Project: Mankato to Mississippi River Project  
23-157

**Supplemental Information Inquiry 2**

Project: Mankato to Mississippi River Project  
23-157

## System Illustrations for Supplemental Information Inquiry 2, Question 7

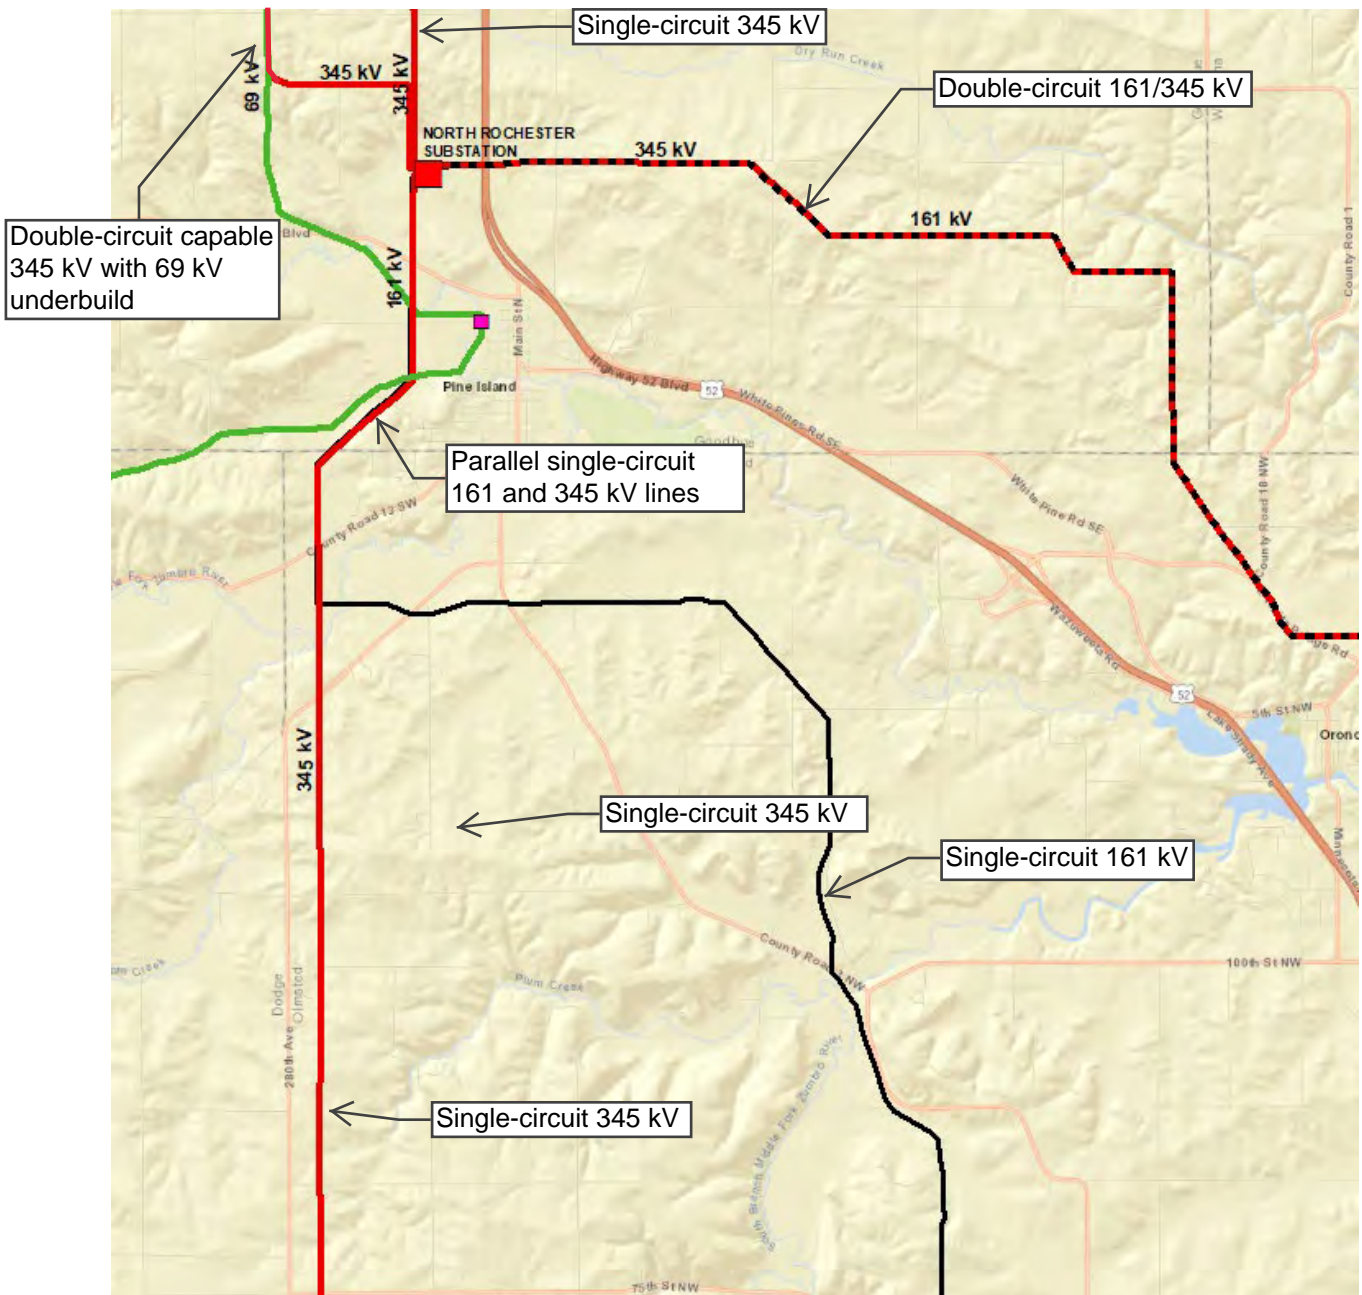
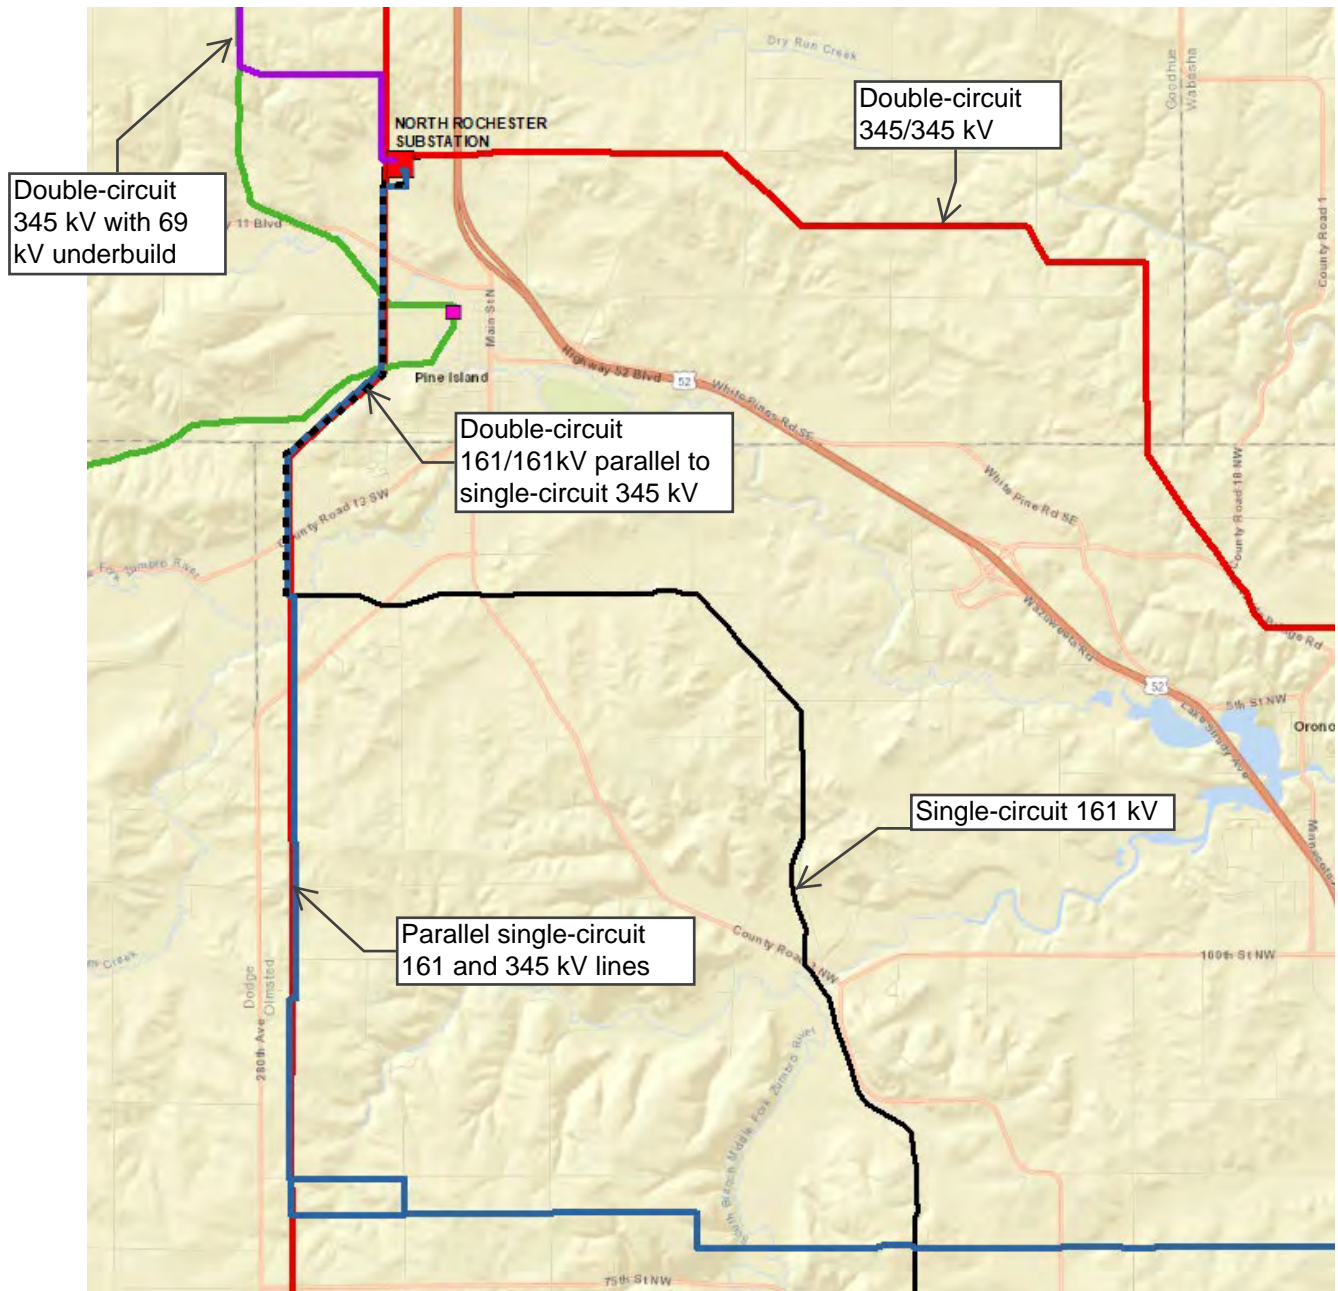
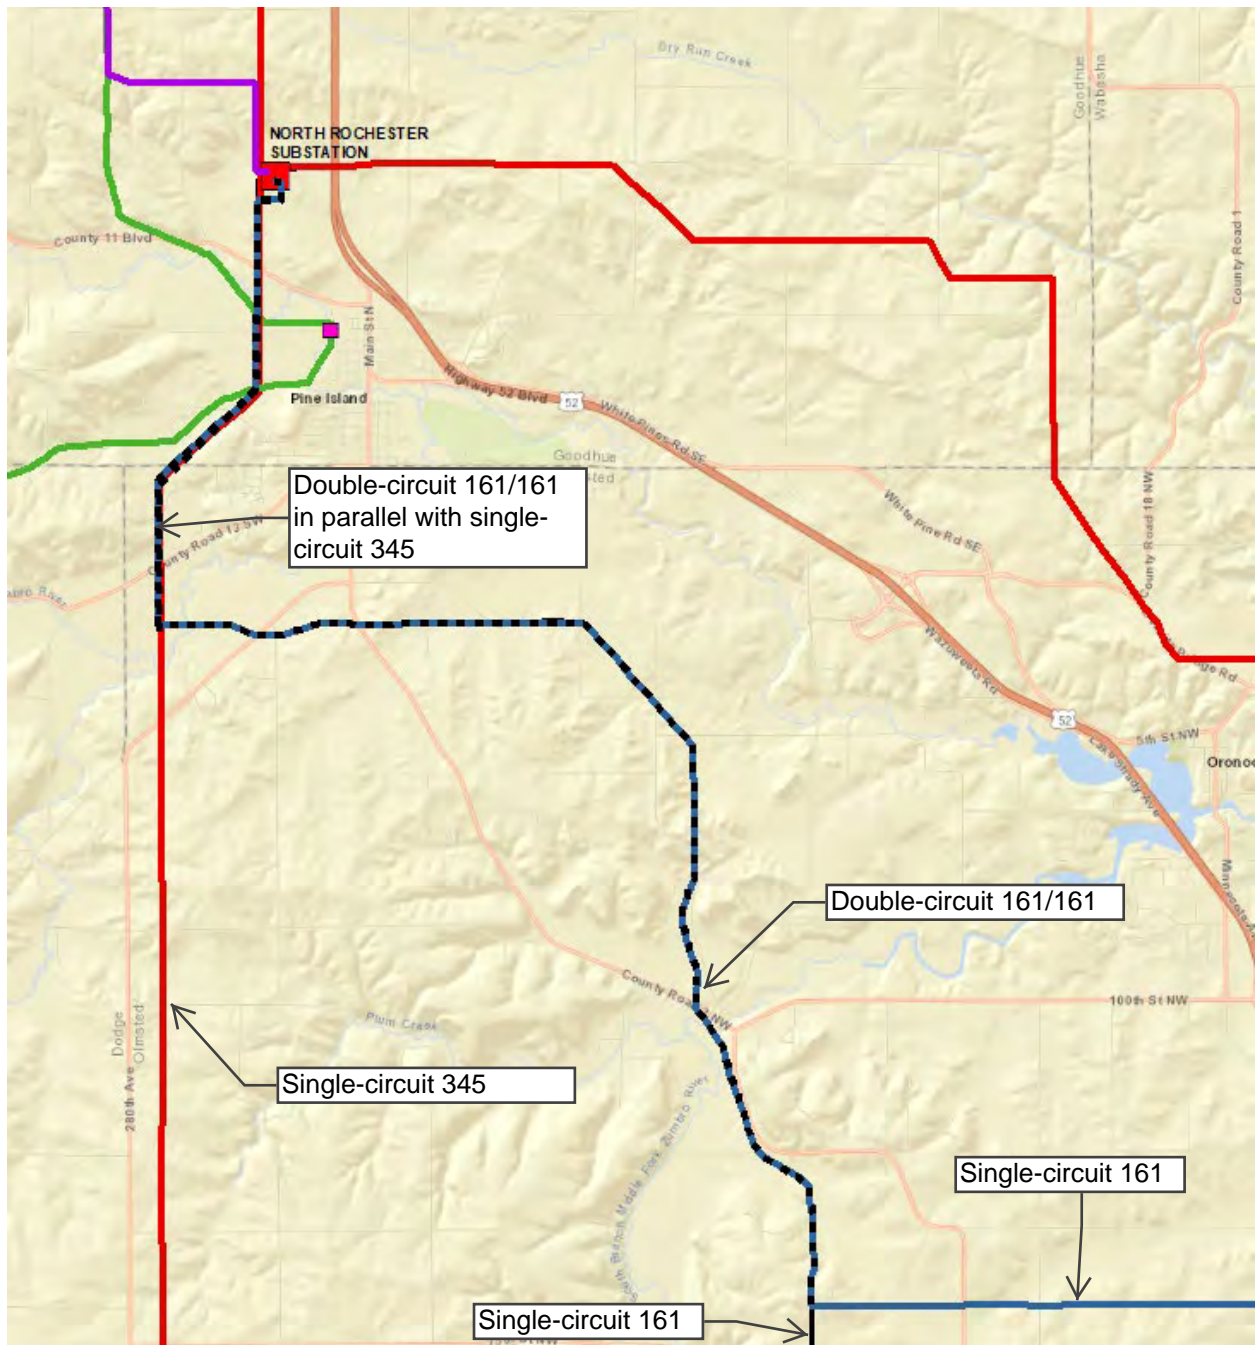
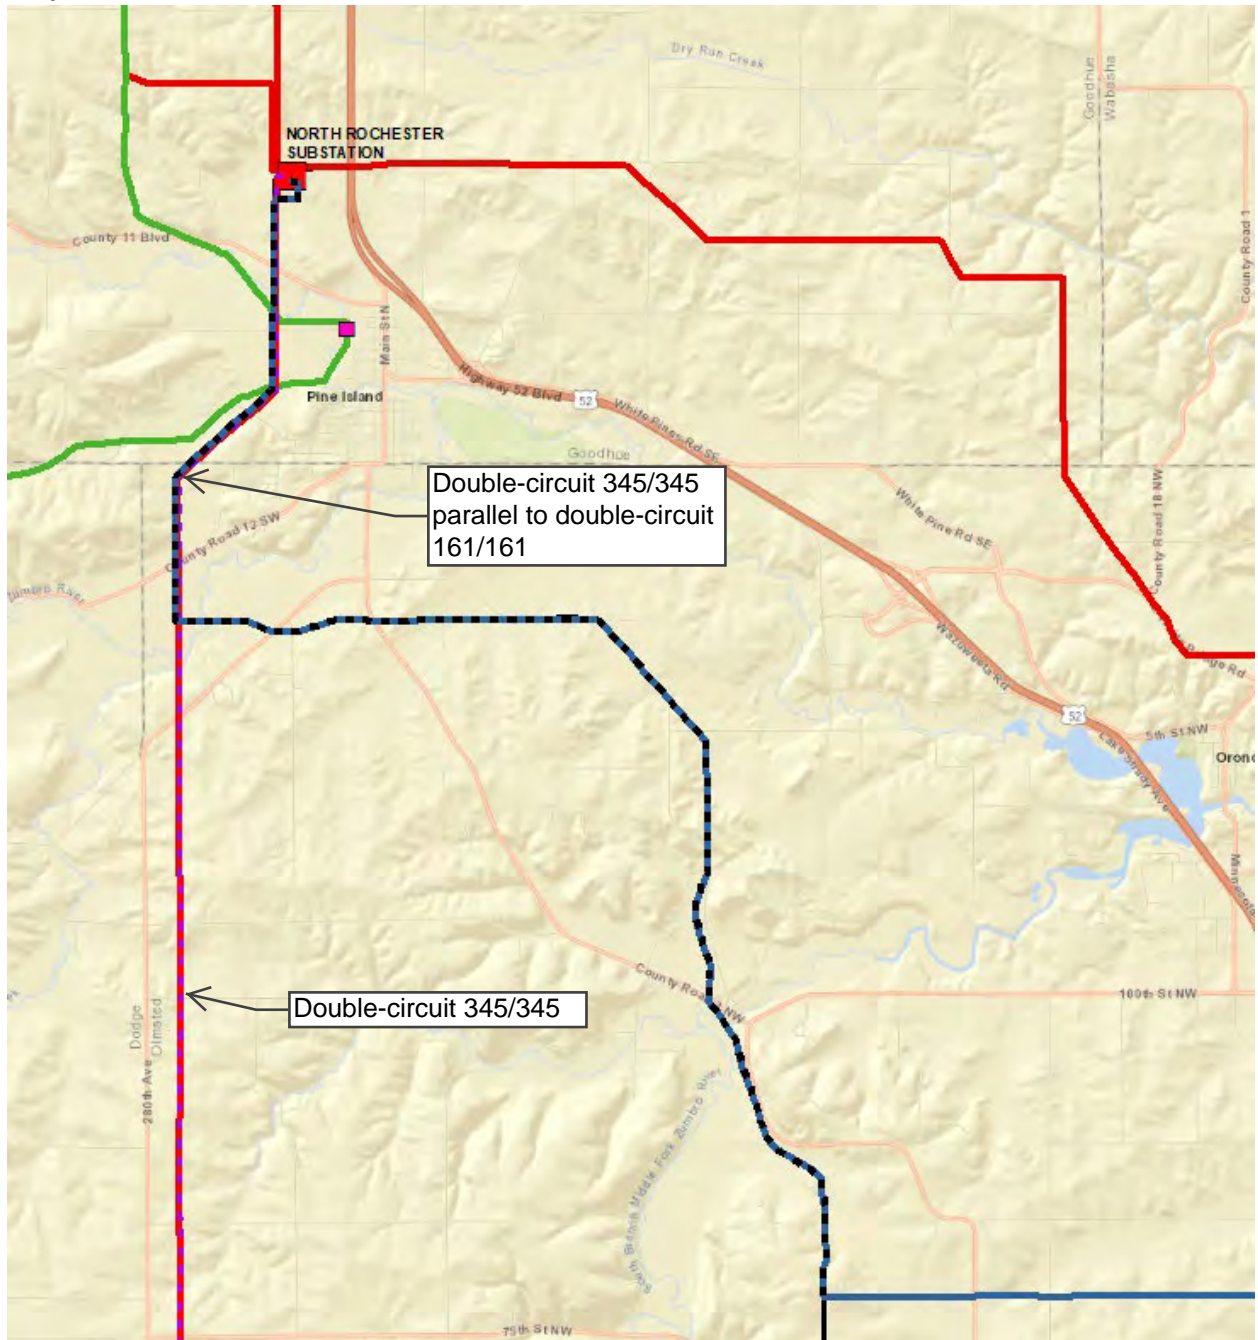
7. This request pertains to Route Segment 17 (Hwy 14 option). In a meeting between Xcel and EERA held on 10/02/2024, EERA and Xcel discussed means of defining an anticipated alignment for the Route Segment 17 (Hwy 14 option). Xcel reiterated that the Route Segment 17 (Hwy 14 option) would need to terminate at the North Rochester Substation (which is also where the applicant's proposed Segment 2 terminates). Xcel's August 28, 2024 letter also noted the need to terminate this alternative at the substation; specifically, your letter stated: "As the Project requires a connection to the North Rochester Substation, a Highway 14 Route Alternative (HWY 14-ALT) would need to also include a new 345 kV connection from the Byron Substation north to the North Rochester Substation." As discussed on 10/02/2024, it is EERA's understanding that should Segment 4 West (as proposed in RPA, this includes: 4K, 4L, 4N, 4H, 4O, 4P) be selected by the Commission as part of the final route, the anticipated route corridor for the portion of the Route Segment 17 (Hwy 14 option) going north/south between the Byron Substation and the North Rochester Substation would be one in the same as the north/south portion of Segment 4 West between the Byron Substation and the North Rochester Substation. Xcel noted this would imply that there could be two lines running north/south. Please confirm that two lines running north/south in this area would be constructable and feasible. Please also confirm if double circuiting is a potential in this area.

Segment 4 of the MMRT project includes the relocation of a portion of the 161 kV line between North Rochester and the Chester Substation (east of Rochester). No portion of the Segment 4 is proposed to be double-circuited with the existing 345 kV line (see question 5 above for more on this item). If Segment 4 West is selected approximately 3.3 miles of the new line would be double-circuited with the existing North Rochester to Northern Hills 161 kV line. If Route 4 West-A is selected approximately 11.3 miles would be double-circuited with the existing 161 kV line.

Note, there are a number of existing lines in this area that connect to the North Rochester Substation. The enclosed System Illustrations for Supplemental Information Inquiry 2, Question 7 shows the configuration and locations of the lines that would result from the project for the following potential route choice combinations:

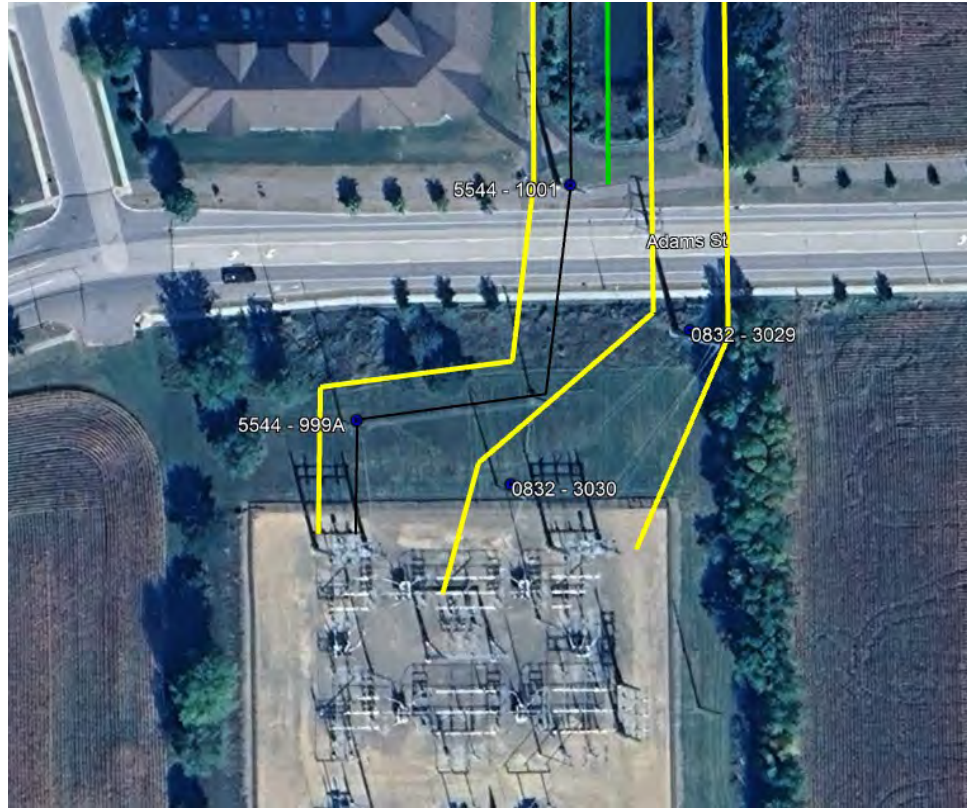
- b. Confirmation that the expansion area and access to it would be on Xcel-owned property.  
**Xcel Energy confirms that the expansion area and access to it will be on Xcel Energy (NSPM)-owned property (also see separately provided shapefile WilmarthSub\_Parcels within above referenced zip file for property boundaries).**

### Option 1 South transmission reconfiguration at Eastwood Substation

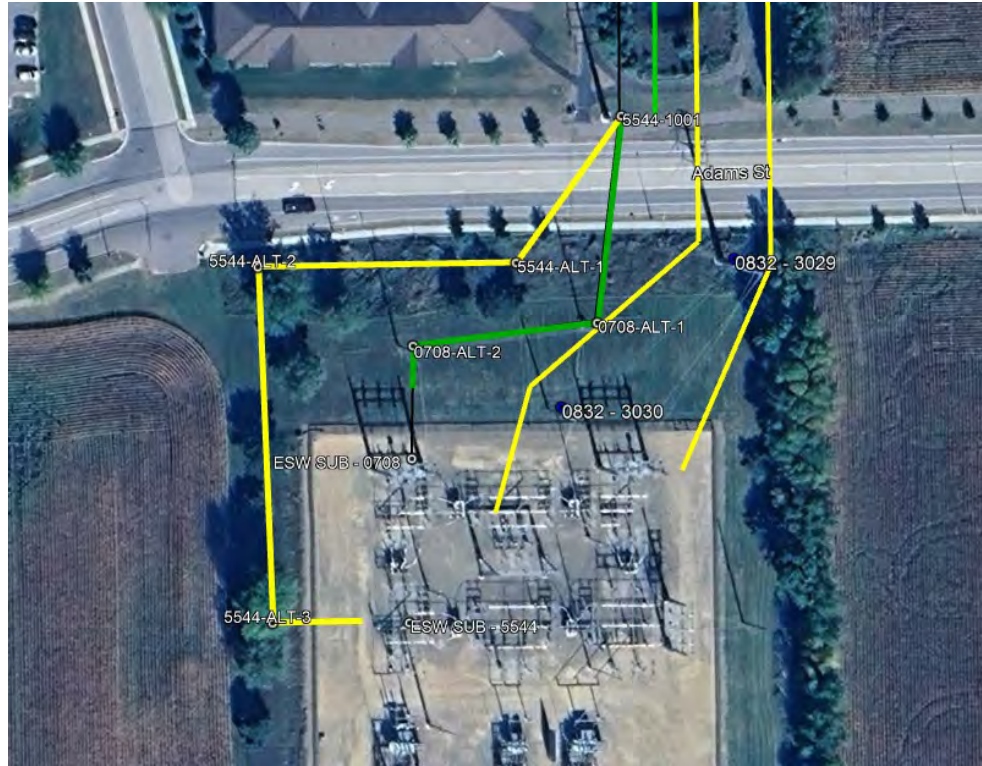
- c. It is also EERA's understanding that if Route Option 1 South were selected, 500 feet of new 69 kV transmission line would be installed to connect the existing line into the substation. Please provide a shapefile indicating where the new 500 feet of transmission line would be located and additional information on why it would be needed.

Yes, that is correct. See screenshots below and attached MMRT\_EastwoodSub\_Shapefiles\_20250124. The additional 500 feet of 69 kV is necessary to connect the line to the Eastwood Substation. The first figure shows the existing configuration where the 69 kV line (green) terminates just north of the substation but does not connect to the substation. The second figure shows the proposed re-termination for the 115 kV line 5544 and proposed new termination of 69 kV line 0708 into the Eastwood Substation.

Figure 1:

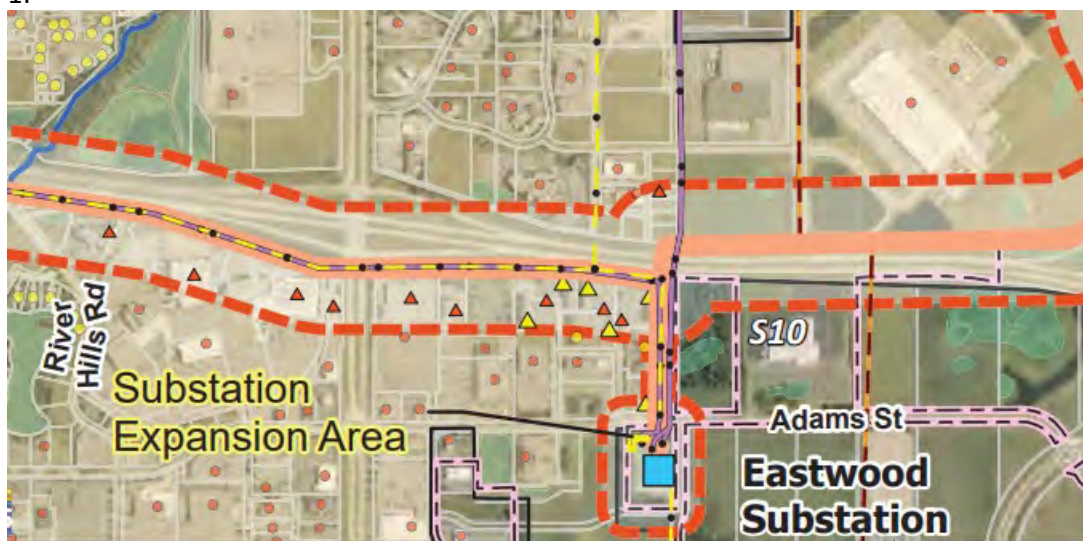
- d. Confirm the expansion area would be contained within the area outlined in orange around the existing substation area in Figure 1 below. Note that Figure 1 is a snippet from the application's detailed mapbook for Segment 1, pg 1 of 11. This additional route width was not included in the original shapefile of the project area provided by Xcel to EERA in August 2024. EERA will include the additional route width area in the EIS's analysis upon confirmation of this information request.

Confirmed; the expansion area noted and shown in the attached drawings is encompassed within the orange dashed project area boundary shown in the figure below.

Figure 2:

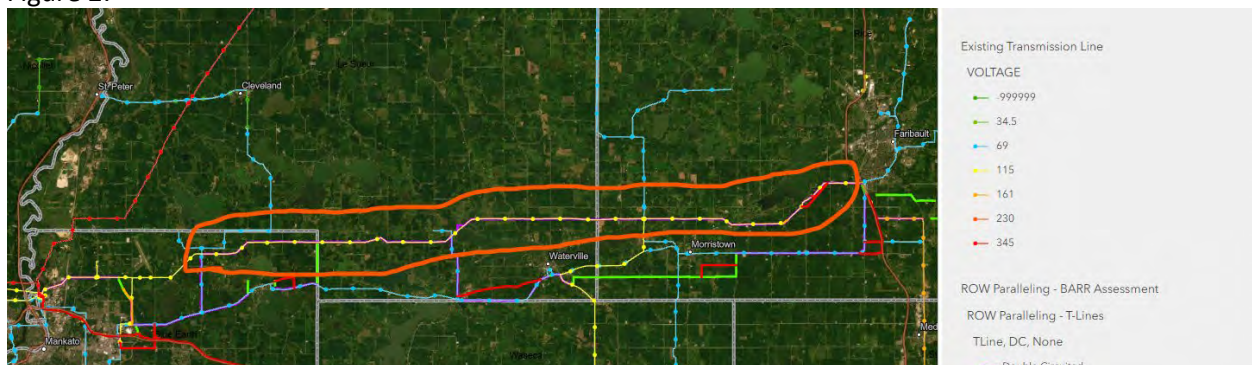
5. Please confirm if the part of Segment 2 circled in orange below would be double-circuited with an existing 69 kV line or a 115 kV line. The application indicates it would be double-circuited with an existing 69 kV line. However, EERA/Barr's spatial data indicates there is only a 115 kV line within the circled area.

The area circled in the screenshot below is a portion of Route Option 1 North, which would involve double-circuiting the proposed 345 kV transmission line with an existing 115 kV transmission line. Route Option 2 North is to the east of the area shown in the image below. (Note: Route Option 2 North involves double-circuiting the proposed 345 kV transmission line with an existing 69 kV line for a portion of the route)
